From:	Selim <Selim@sawayaeng.com>
Sent time:	06/25/2019 11:51:02 AM
To:	Ron Dragoo; allan rigg <allanrigg@yahoo.com>
Cc:	Scott Campbell <scampbell@trumpnational.com>
Subject:	2019-06-25 # Tract 50666 # Request for Storm Drain Amendment
Attachments:	2019-06-25 SD Request2City.pdf

Re: **Request to use Forestall Canyon to convey off-site storm water in lieu of the proposed 60 inch Reinforced Concrete Pipe.**

On behalf of VH Property, Sawaya Engineering Consultants has prepared this letter to propose to continue using Forestall Canyon as a storm drain delivery system in lieu of constructing the conceptually approved storm drain pipe as shown on the 2005 Amended Grading Plan of Phase II, as described below.

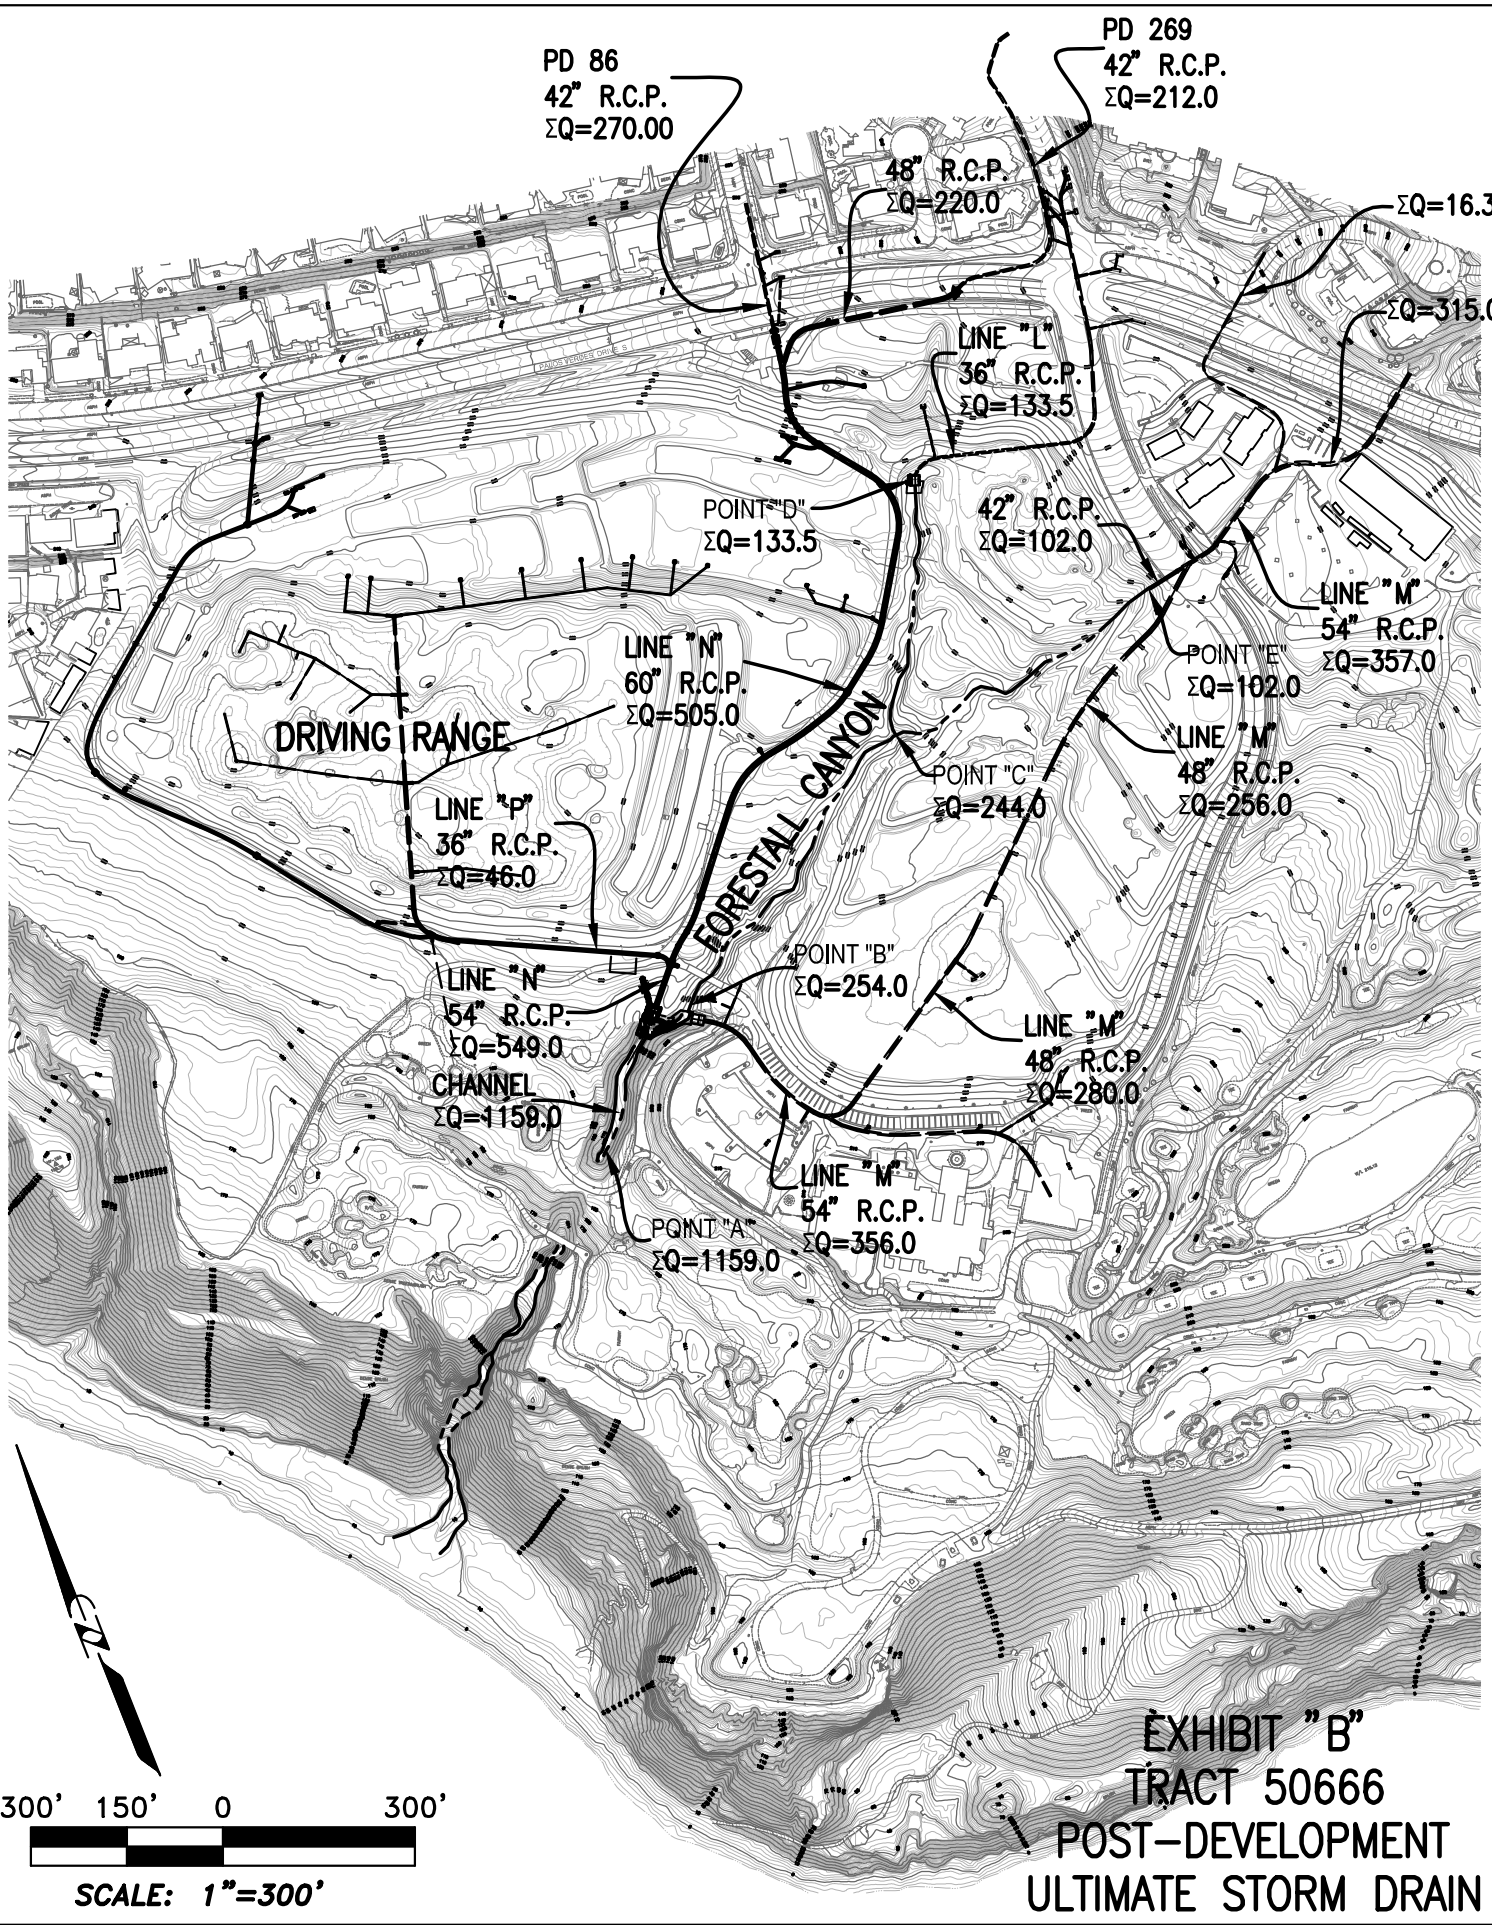
The Drainage Concept of the development as proposed in 2000 and shown on Exhibit "B" was set to reduce / minimize the risk of flooding of the proposed lots from Forestall Canyon. As a result, the flow within Forestall canyon was reduced from 1050.0 cfs at Point "B" to approximately 254.0 cfs. The balance of approximately 800 cfs was to be conveyed back to Forestall Canyon downstream of the proposed lots at Point "B" via a storm drain piping system.

The storm drain systems per PD 86 and PD 269 were existent prior to the development. Line "L" and Line "M" were constructed in 2004 and have been in operation since. The only remaining storm drain lines to be constructed for the development to satisfy the approved Drainage Concept are Line "N" and line "P" (See Exhibit "B").

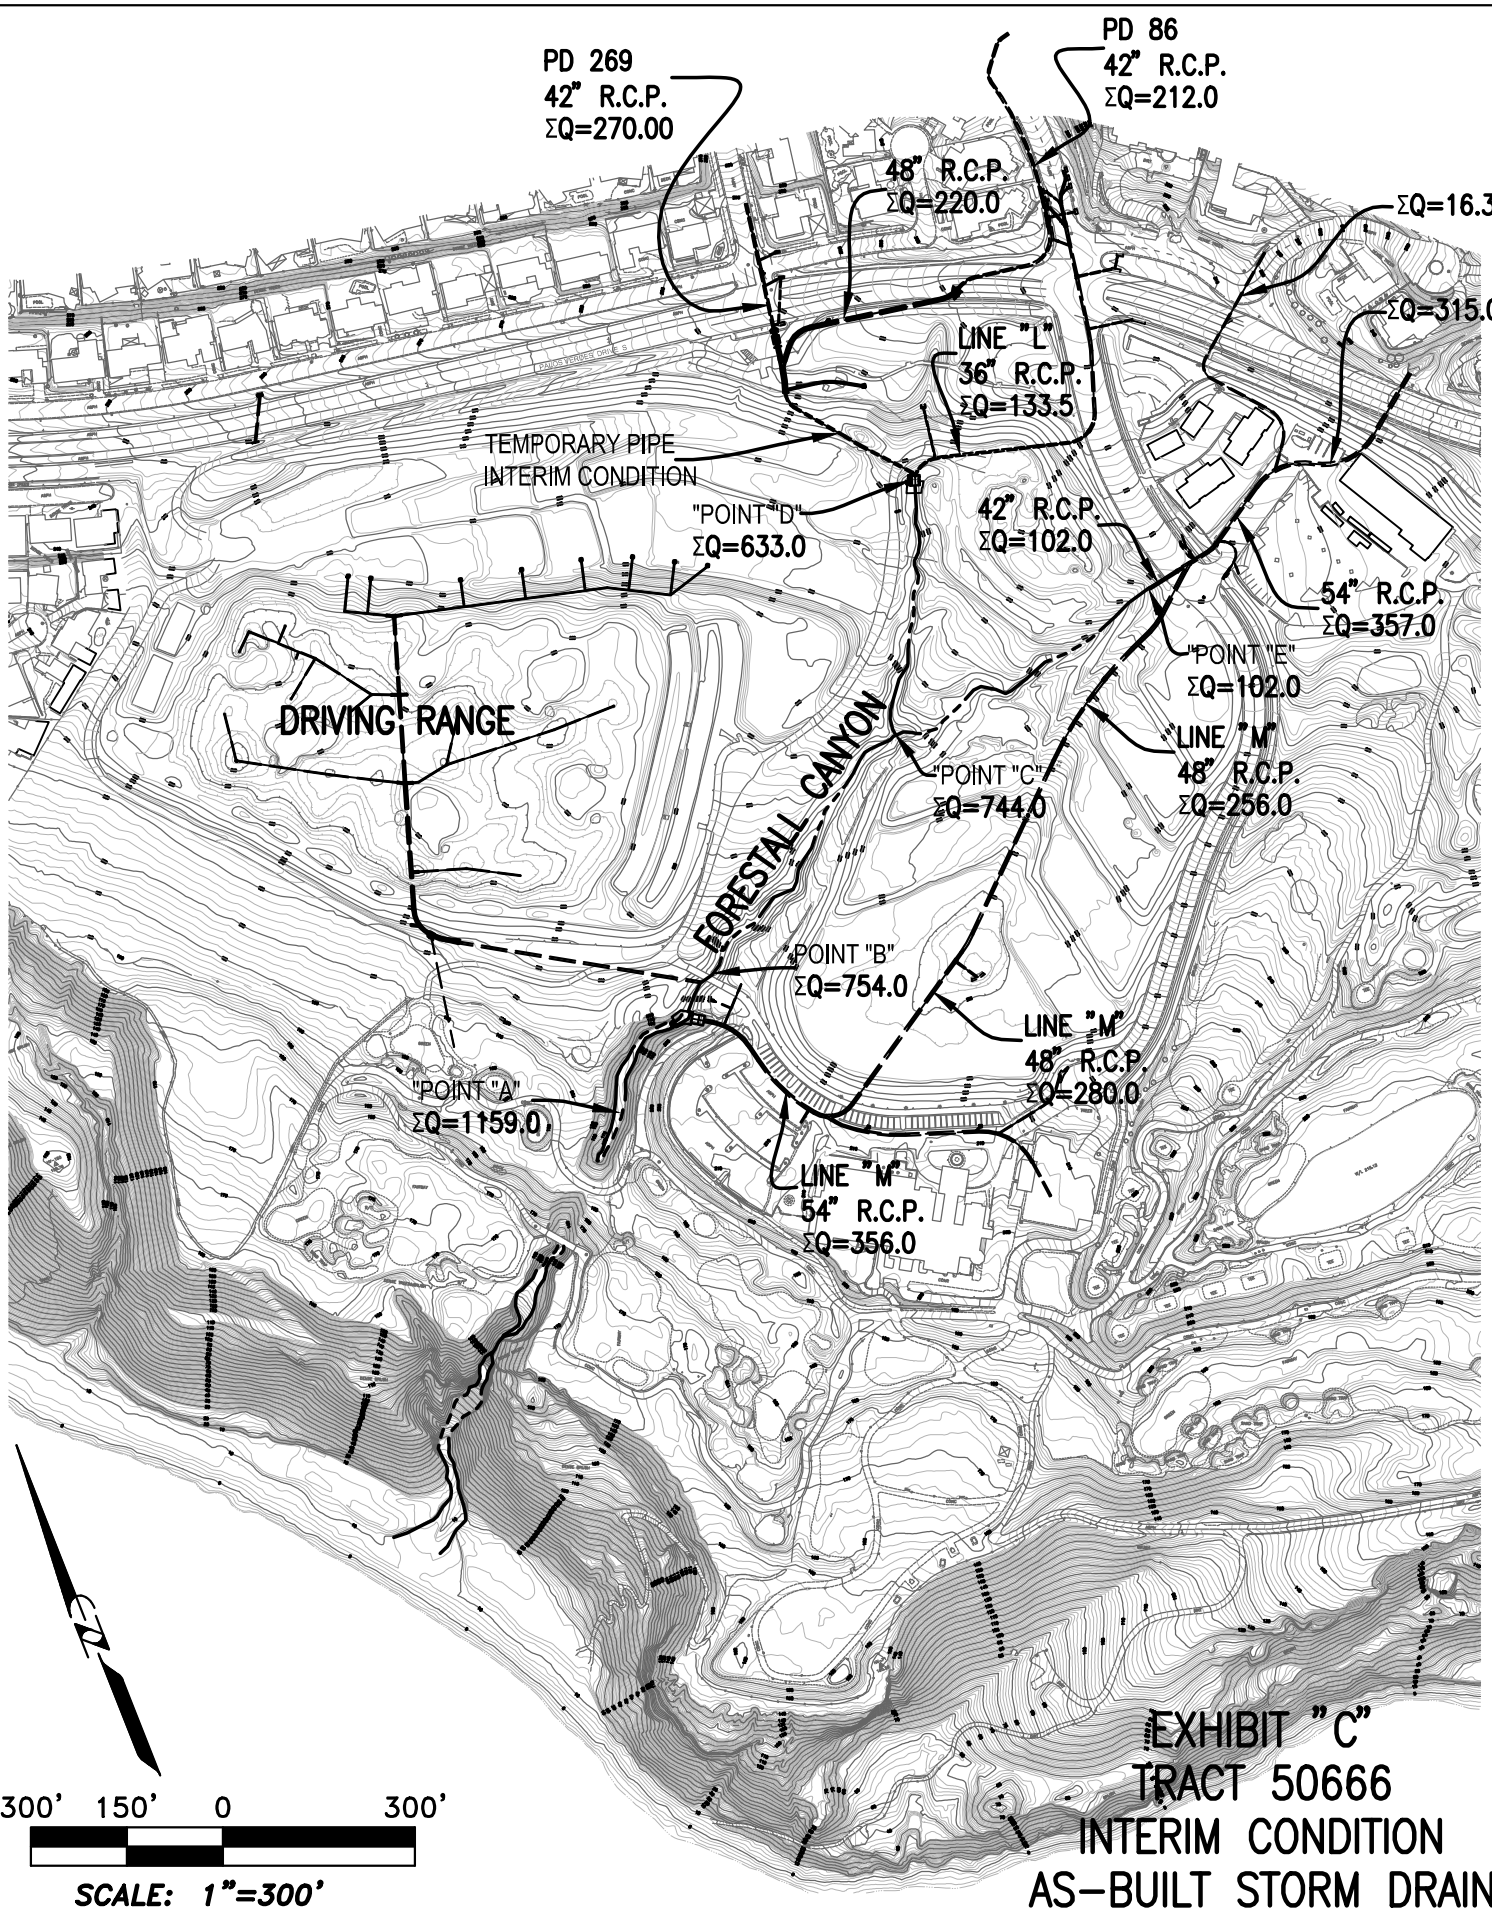
In the interim and until the ultimate drainage system is completed, a temporary pipe was constructed in 2005 to convey the flow of PD 86 and PD 269 back to Forestall Canyon (See Exhibit "C"). Since 2005, (approximately 15 years), the flow within Forestall Canyon between Point "D" and Point "B" has ranged from 633.0 cfs to 754.0 cfs, which is below the historical / predevelopment flow of 1050.0 cfs.

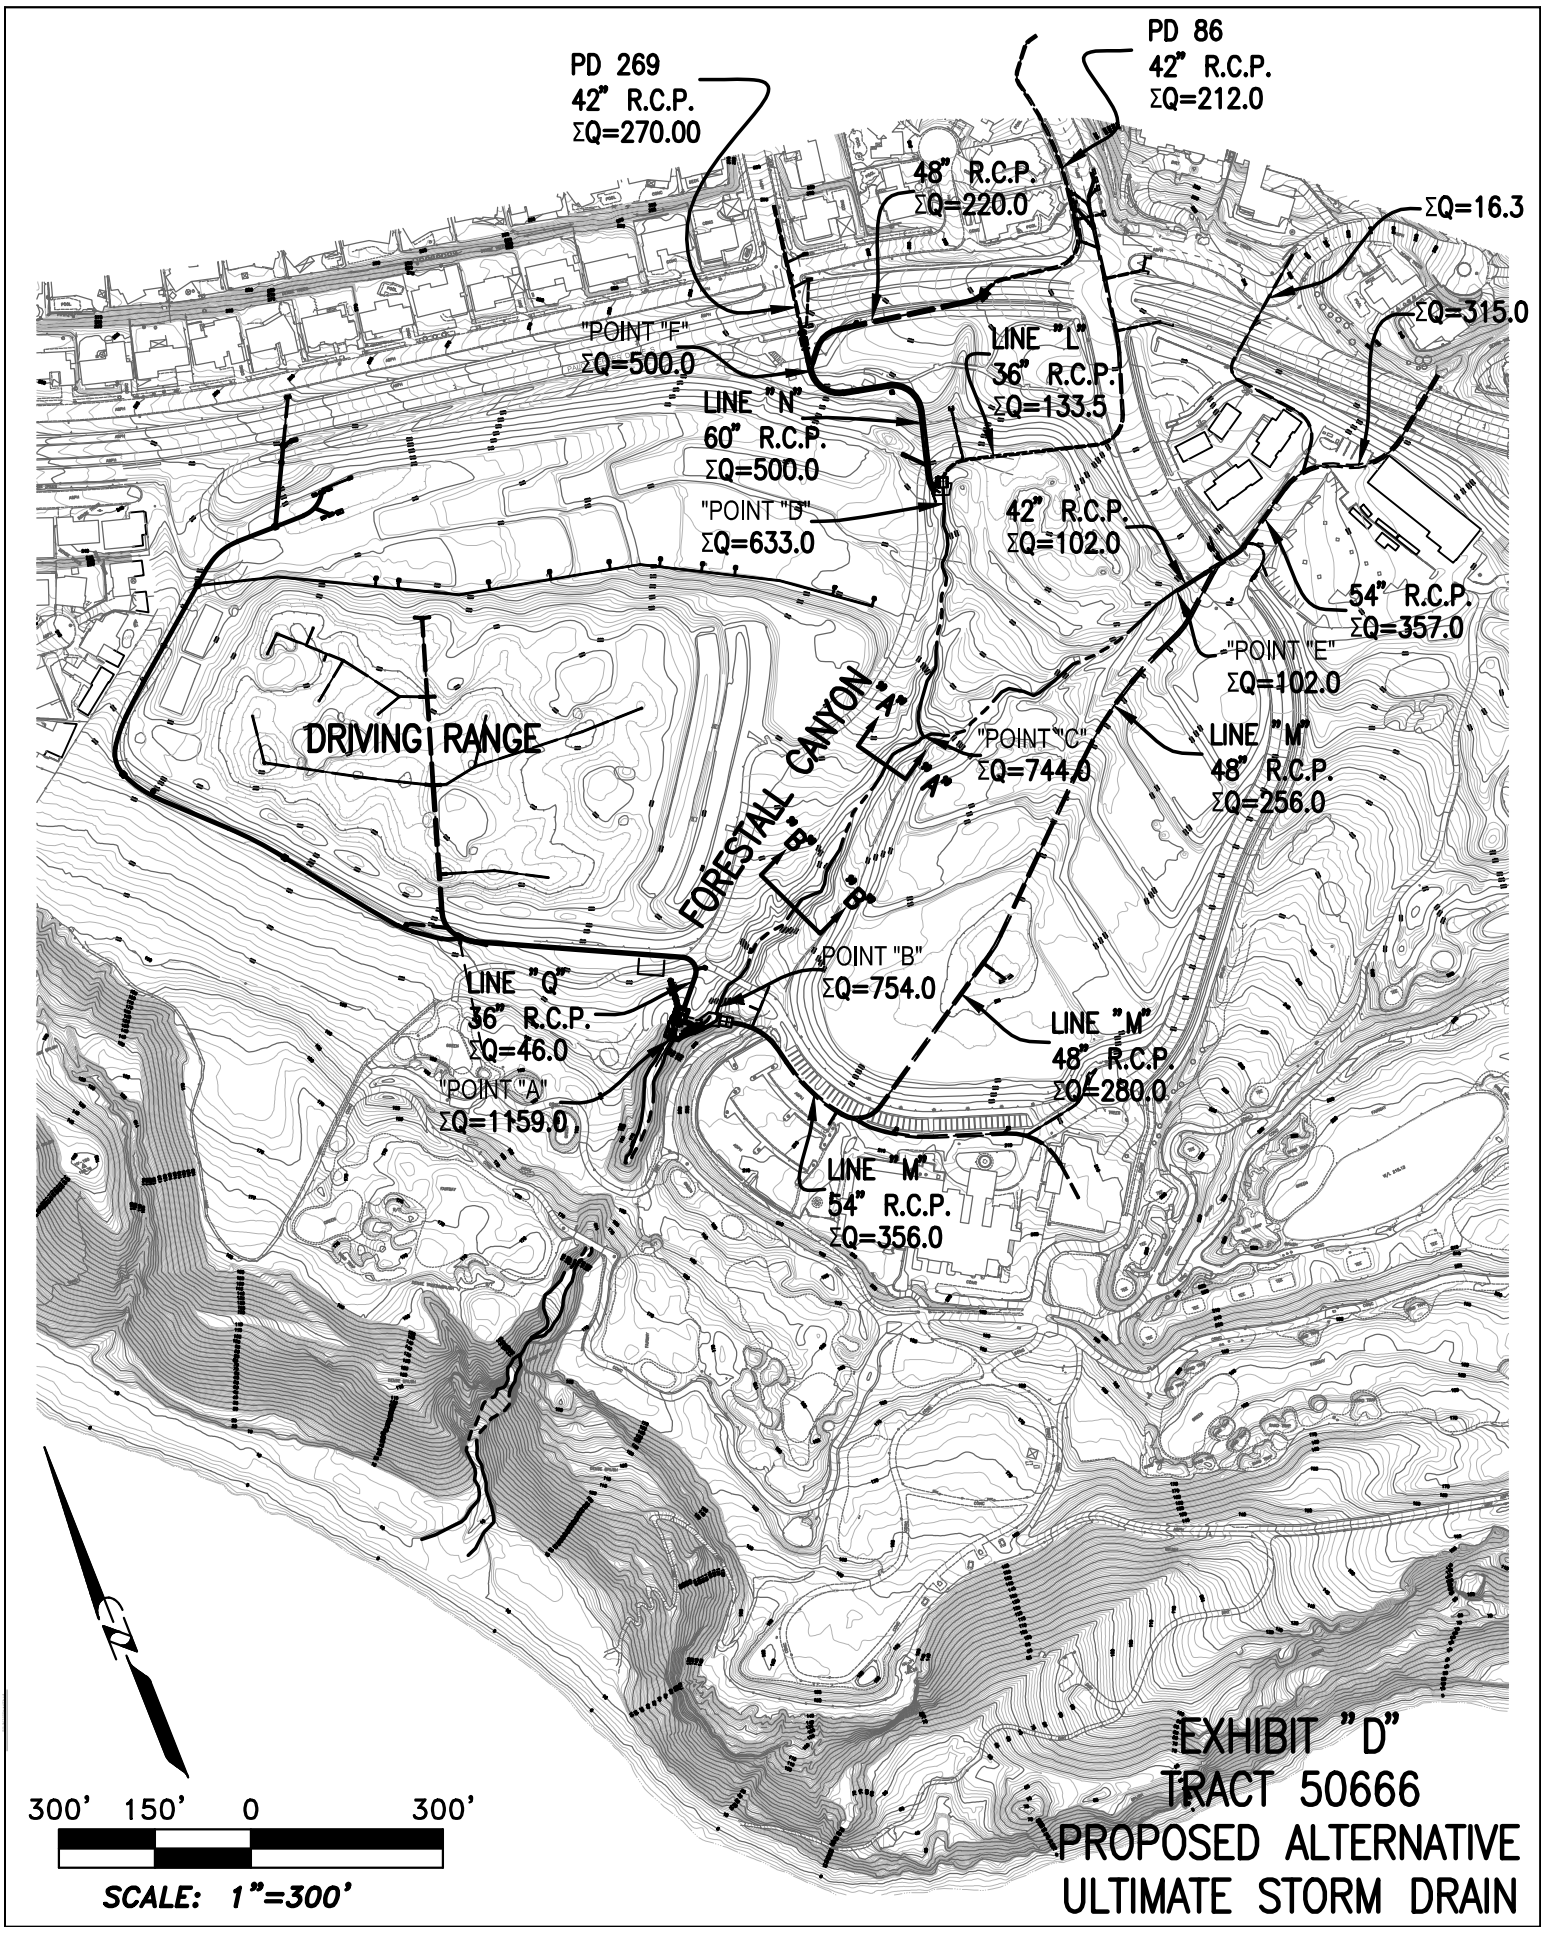
In 2005, an amended loting configuration for the site was approved and graded to provide for a driving range in lieu of 16 residential lots, thus reducing the number of residential lots west of Forestall Canyon from 29 to only 13 lots. The amended site as approved and graded has reduced and likely eliminated the risk of residential flooding from Forestall Canyon rendering the proposed Line "N" (60" RCP) redundant and unnecessary. Therefore, VH Property is requesting the City of Rancho Palos Verdes' approval to eliminate the portion of Line "N" that is adjacent to Forestall Canyon from Point "B" to Point "D".

In the event that the above request is granted, Line "N" would have a design flow of approximately 500 cfs, would start at Point "F", and would terminate at Point "B" with an energy dissipater type outlet structure (See Exhibit "D" for size and alignment).

Line "Q" would have a design flow of approximately 46 cfs and would terminate at point "A" with an energy dissipater type outlet located (see Exhibit "D" for size and alignment).

EXHIBIT "E"
TRACT 50666
PROPOSED ALTERNATIVE
HYDRAULIC CALCULATION

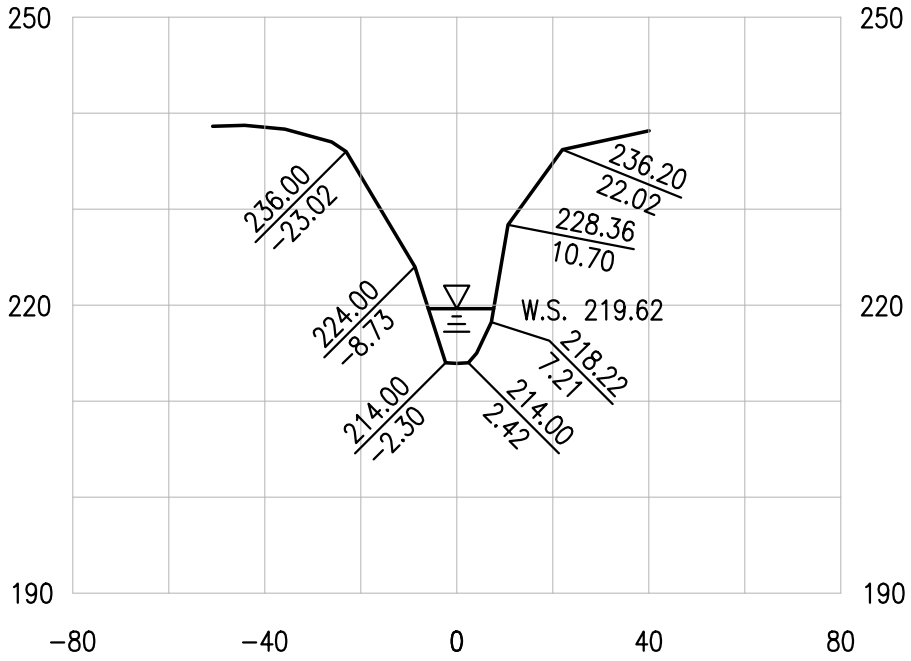
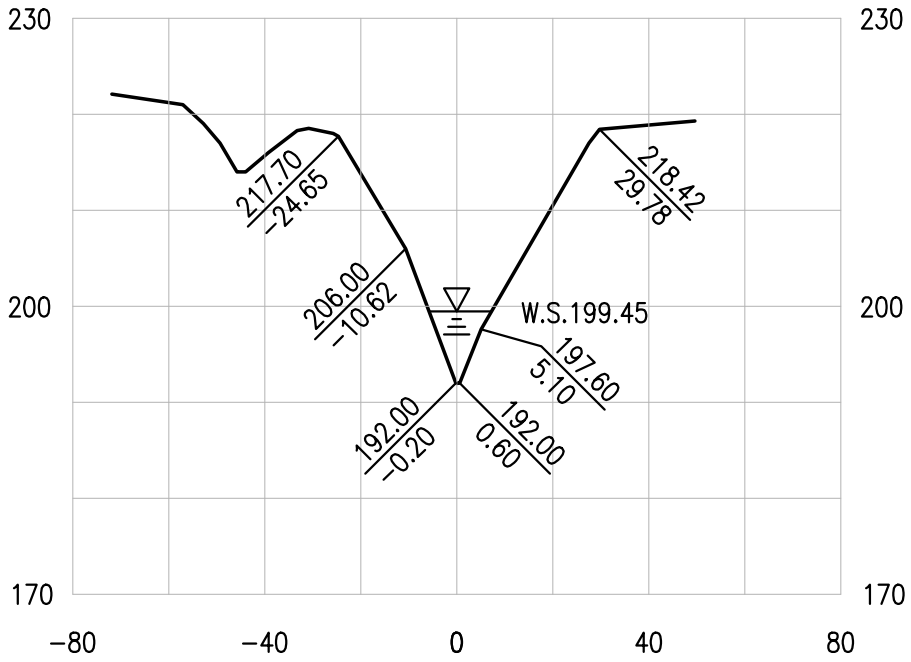
5. No Residential lots would be at risk from flooding and high velocity scouring action.
6. Forestall Canyon has the capacity to carry the anticipated flow with a velocity less than 15 fps. (See Exhibit "E" for water surface elevation and velocity).
